AGENDA ITEM: **201401628** - 85 Johnson Ferry Road, *Applicant: Waterford Homes*, to rezone the subject property from R-3 (Single Family Dwelling District) to R-5 (Single Family Dwelling District) to allow for the development of three (3) single family residences, with concurrent variances

Agenda Item: **201401628 85 Johnson Ferry Road** a request to rezone the subject property from R-3 (Single Family Dwelling District) to R-5 (Single Family Dwelling District) to allow for the development of two (2) single family lots, with concurrent variances.

DEPARTMENT OF COMMUNITY DEVELOPMENT RECOMMENDATION

RECORDING PLAN FOR:
WATERFORD HOMES
TAX ID 17-012520010023 - 45 JOHNSON FERRY ROAD ZONED R5
TAX ID 17-012520010048 - 122 BELMONT TRACE ZONED R5

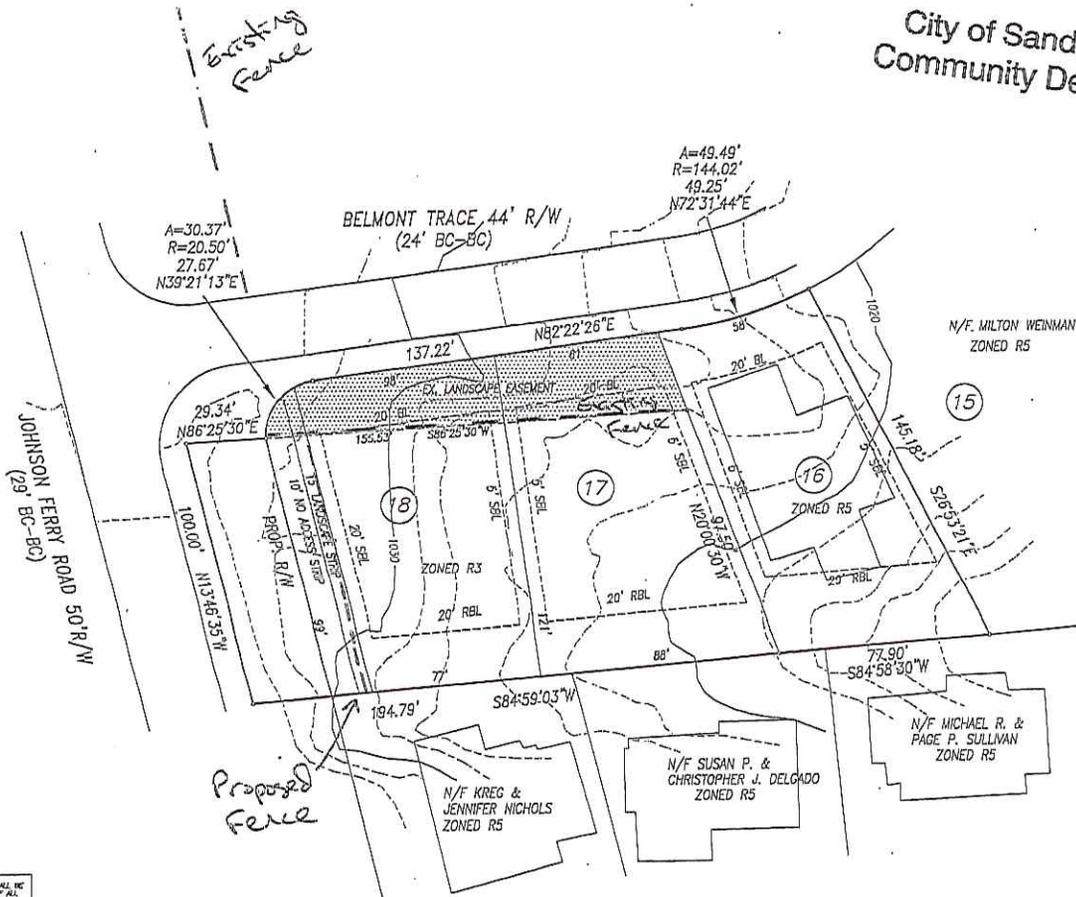
There are two wastewater manholes north of the northern property line of the 0.424 acre tract (85 Johnson Ferry Road) (sewer manholes # **SMMA1008030** and # **SMMA1008040**) located in Land Lot 125, District 17 that can service this location.

VIEW 'A'
SIGN COLUMN / FENCE ELEVATION
17'-0" x 1'-0"

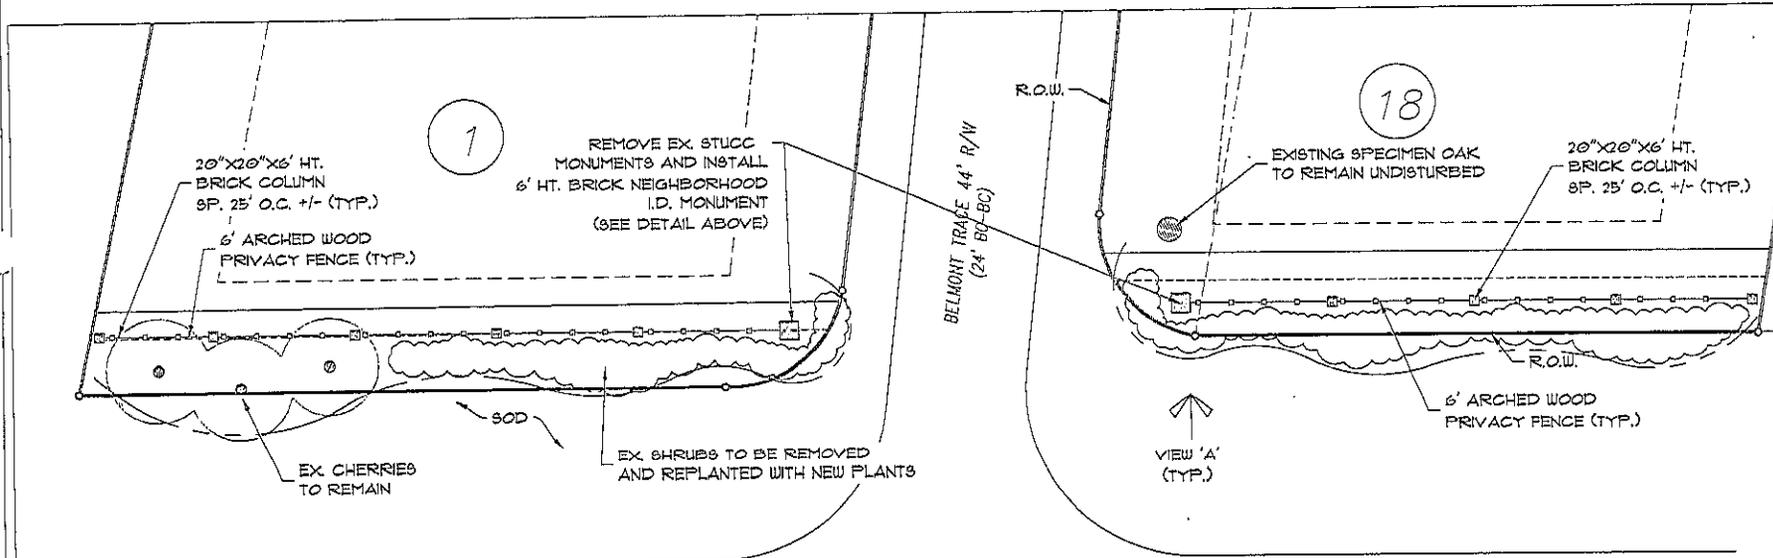
3. Variance from section 33.22.c to reduce the setback from ten (10) feet setback to zero (0).

Staff is of the opinion that the request to reduce the setback from ten (10) feet to zero (0) is in harmony with the intent of the Zoning Ordinance and would not be a detriment on adjacent properties. The existing fence is currently located in the right-of-way. The applicant has consulted with the Public Works Department regarding the proposed fence location. Additionally the sign will be part of the fence column. Therefore, based on these reasons, the staff recommends APPROVAL of this variance request.

1. To the owner's agreement to provide the following site development standards:
 - a. Variance from section 4.11.G.3.b to allow a fence over four (4) feet in height to not have a picketed design on the south side of the Belmont Trace entrance.
 - b. Variance from 4.11.F to reduce the fence setback from three (3) feet to zero (0).
 - c. Variance from 33.22.c to reduce the sign setback from ten (10) feet setback to zero (0).
 - d. No vehicle access shall be permitted on Johnson Ferry Road.
